Vincotech – PCN – No 02-2019

SUBJECT OF CHANGE:	Improved design of <i>flow</i> 90 1 housing
PRODUCTS AFFECTED:	See list below
REASON OF CHANGE:	Reliability improvement by more robust housing design

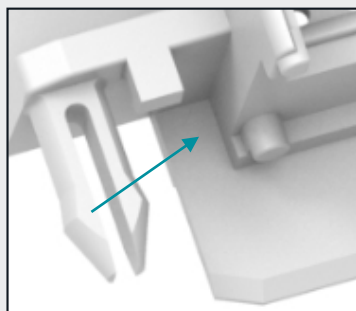
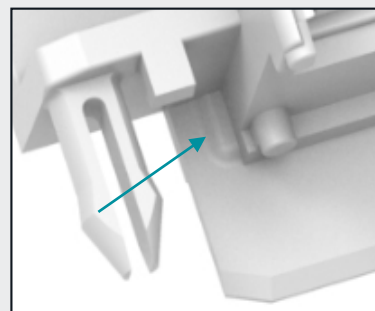
Increase cross section on the housing by small plastic addition (see pictures)

No impact on handling and assembly process

No impact on PCB design
